RE: Marsh Landing Generating Station
Application for Certification 08-AFC-03

Responses to Data Request Set 3: (#70–98)

Application for Certification (08-AFC-03) for MARSH LANDING GENERATING STATION Contra Costa County, California

FIGURE 80-1

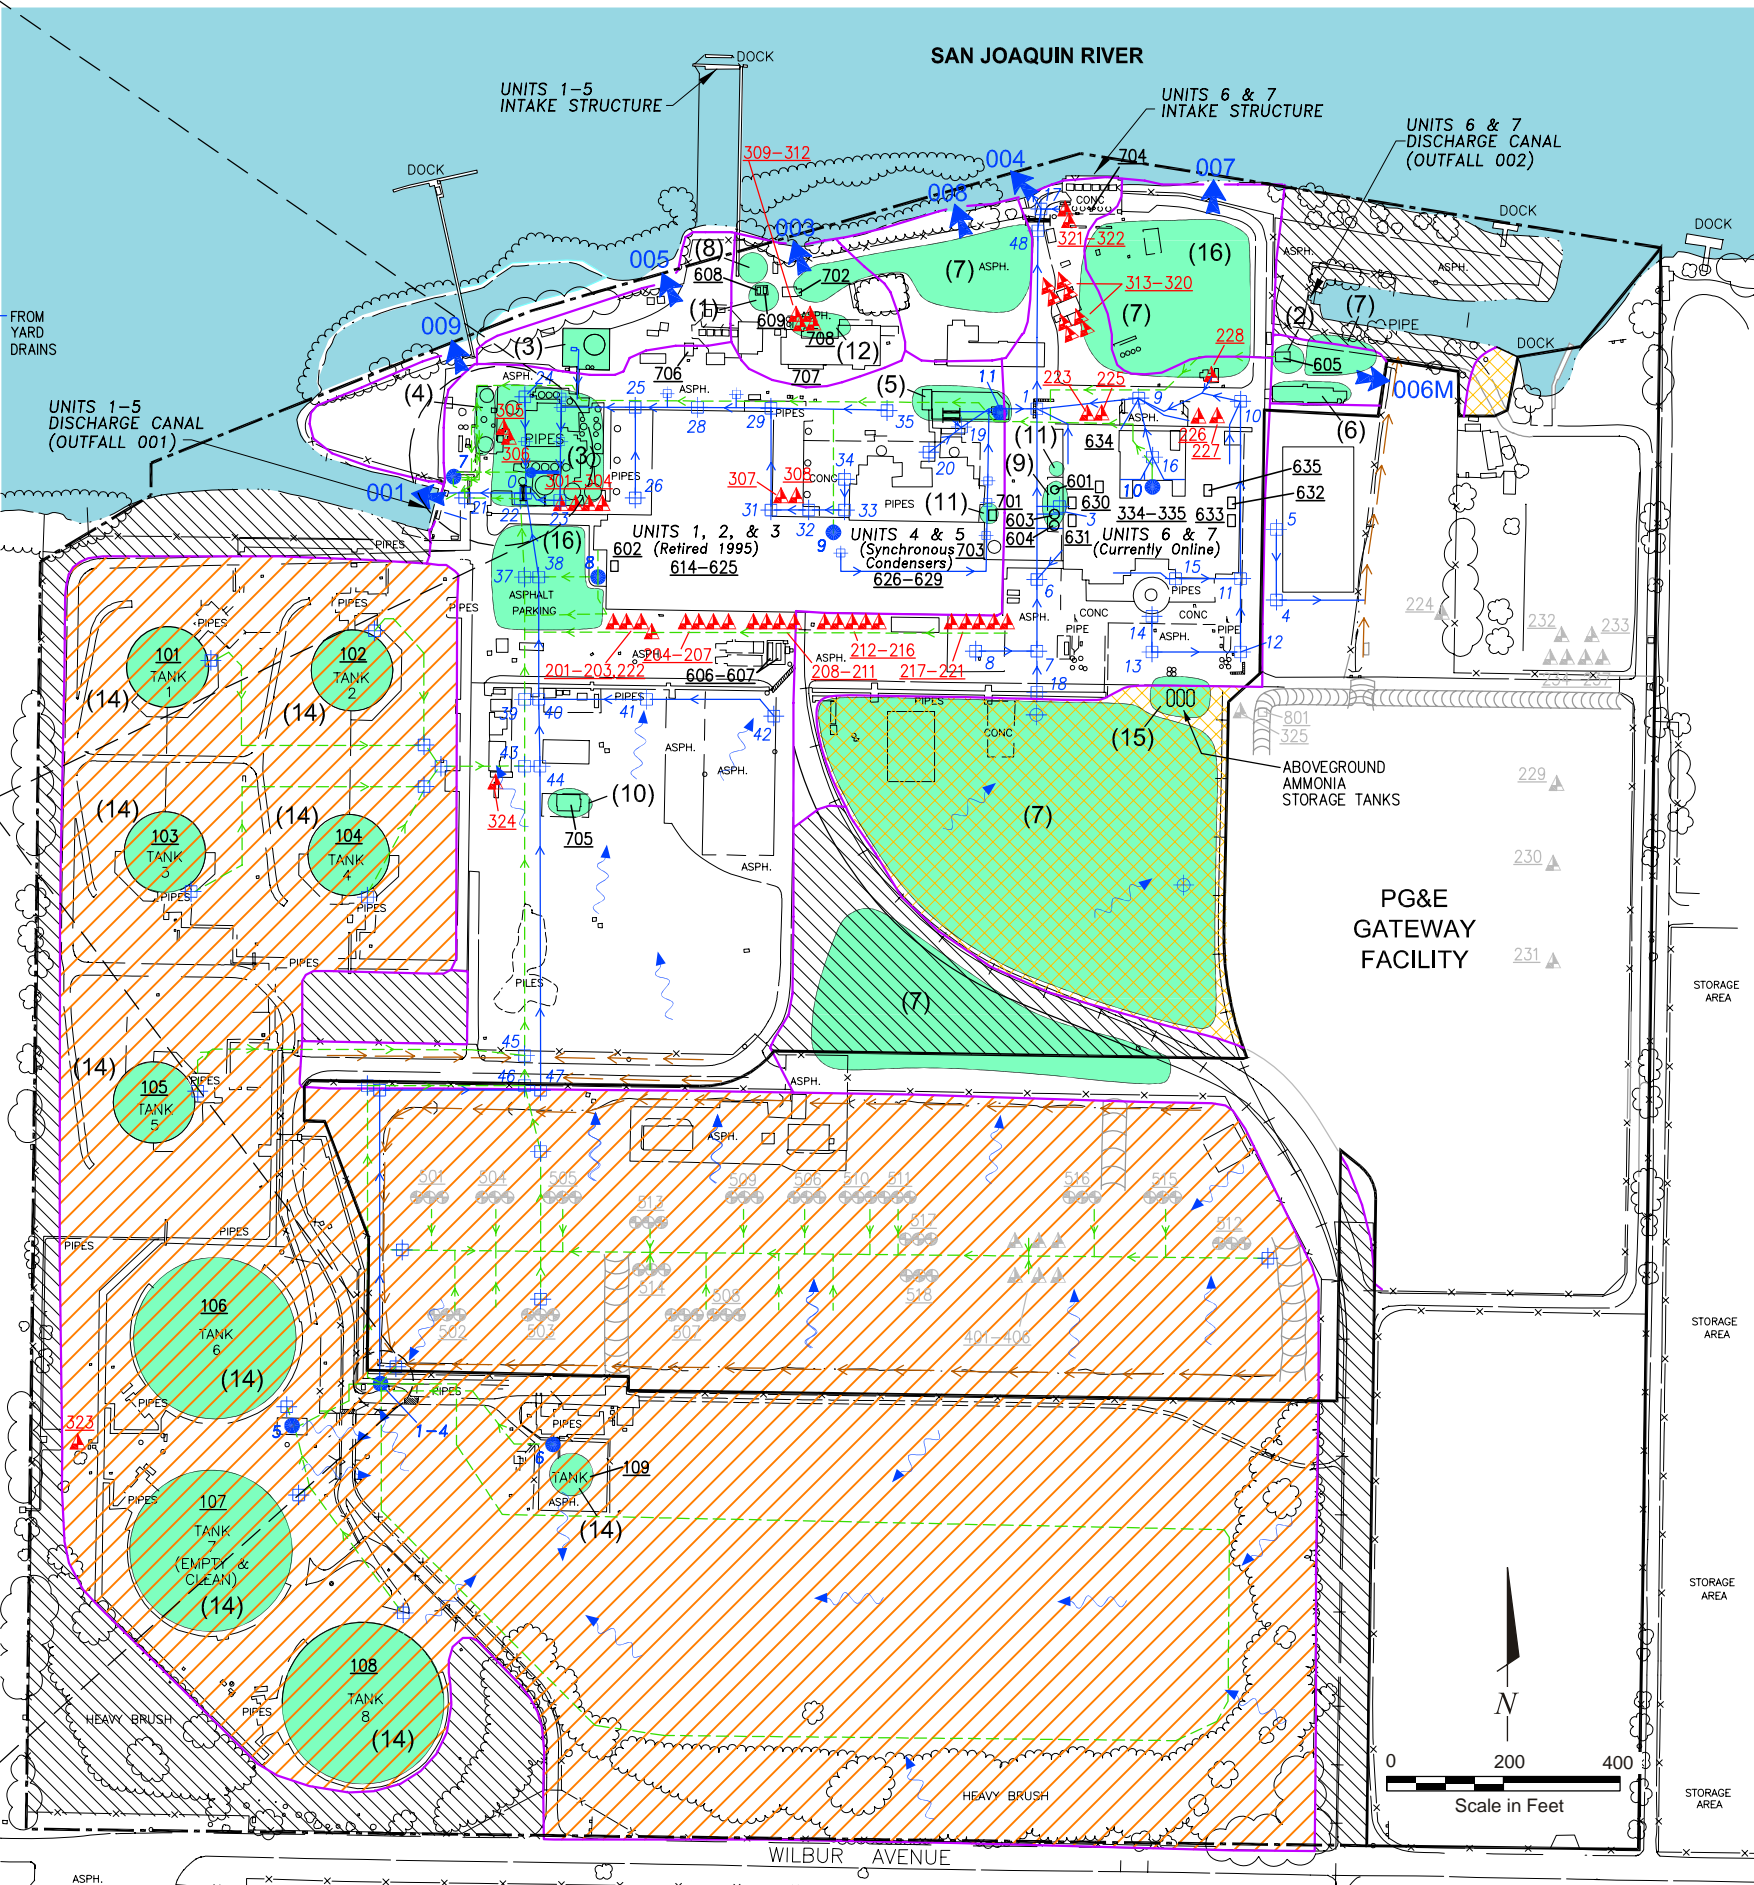
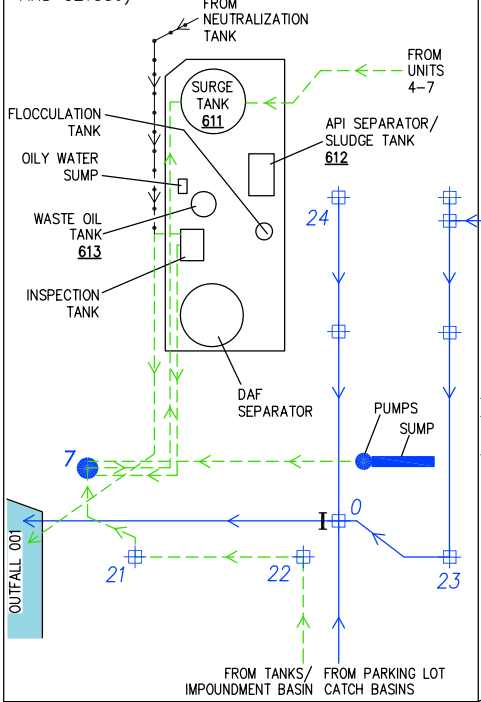
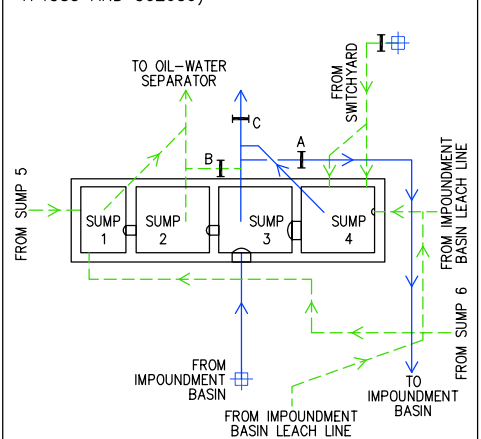
80. Provide a qualitative comparison of pre- and post-project drainage efficiency.

The 27-acre MLGS site will be located within the northwestern portion of the 114-acre CCPP site. The CCPP has an existing stormwater drainage system that complies with the State Water Resources Control Board's Water Quality Order No. 97-03-DWQ, NPDES No. CAS000001, Industrial Stormwater General Industrial Permit (General Industrial Permit). AFC Figure 7.14-3, Existing CCPP Drainage, which is based on Figure 2 of the CCPP Stormwater Management Plan (Mirant Delta, 2007), shows the existing stormwater drainage system on the CCPP, and is included here as Figure 80-1.

The post-project drainage system will be similar to the existing drainage system. The proposed site drainage plan is shown on AFC Amendment Revised Figure 2.6-2. To accommodate the proposed MLGS, the five existing storage tanks and associated berms and pavement will be replaced with structures, pavement, or gravel. The amount of impervious area created by the project will be approximately 33 percent, which is less than the amount of impervious area currently present at the site. While compacting the soil to support the proposed facility would reduce the amount of infiltration, it is anticipated that, overall, there will be more pervious area and therefore less runoff due to the project. Portions of the site with the potential for stormwater contamination will be curbed and runoff from these areas will be contained and then conveyed to the project's new oil-water separator, with ultimate discharge to an offsite sanitary sewer system. Stormwater runoff from the majority of the project site will continue to be collected by a surface drainage system and then discharged to the San Joaquin River via existing CCPP Outfall 001.
